HAZEL

CONSTRUCTION SUMMARY

Forestside Estates Inc.

LOT NUMBER	PHASE	HOUSE TYPE	CLOSING DATE	
253 BLOCK 7	6-III	Hazel 1A	06-Jun-23

BUILDING D SUITE 253 IBLK 7

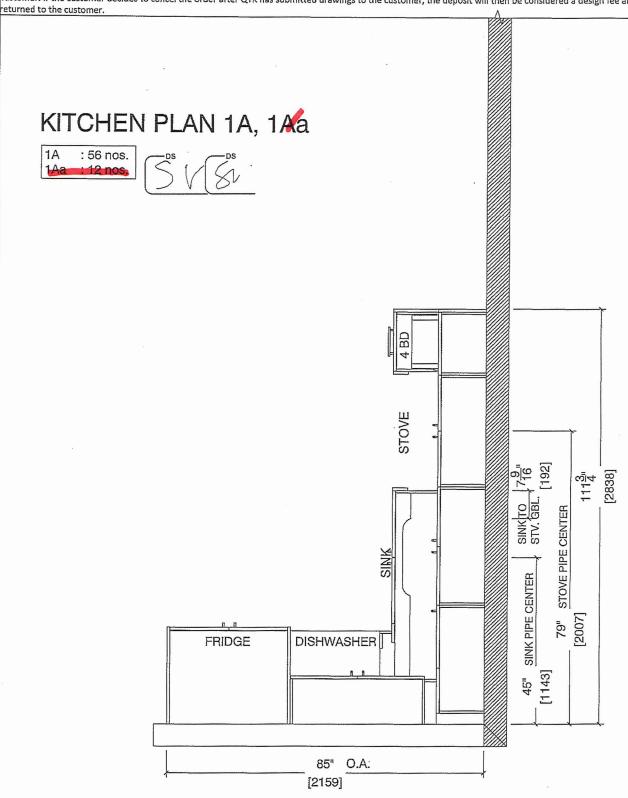
1 - KITCHEN- PLUMBING - Install the UPGRADED UNDERMOUNT sink in the kitchen- Install the BLANCO QUATRUS U1- Model # 401273. To include cut and polish (see sketch)

1 - KITCHEN - COUNTERTOP - Install Builders Standard Stone Countertop - Emmerstone Vanilla White with STANDARD " A " EDGE PROFILE - To be installed throughout kitchen, where applicable (does not include stone backsplash) (See Sketch)

1 - KITCHEN - WALL TILE - Install UPGRADE 1 KITCHEN BACKSPLASH (Glass Tile Twilight Pewter/Smoke) throughout the kitchen in lieu of the builder's standard backsplash. Does not include behind fridge/Stove. (See Sketch)

BUILDING D SOITE 253 BW 7

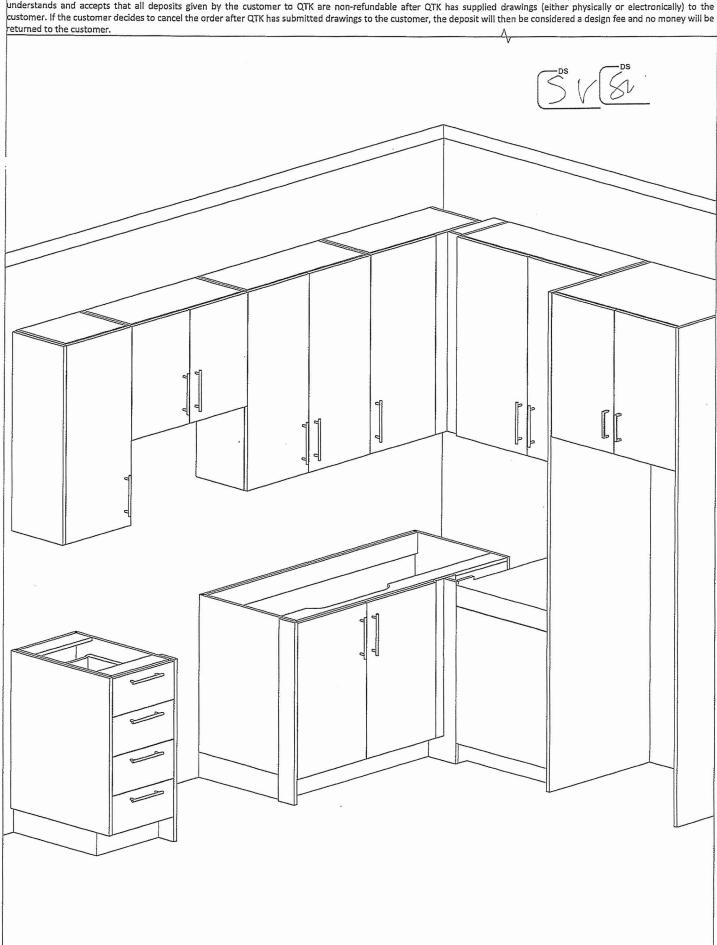
1 - MAIN BATH- Install the Standard 3" Splash throughout all bathroom vanity counter tops, where applicable. To include the Main Bath

1 - MAIN BATH - COUNTERTOP - Install Builders Standard Stone Countertop - Emmerstone Maple White with STANDARD " A " EDGE PROFILE - To be installed throughout the main bath where applicable. To include 3" Splash(See Sketch)
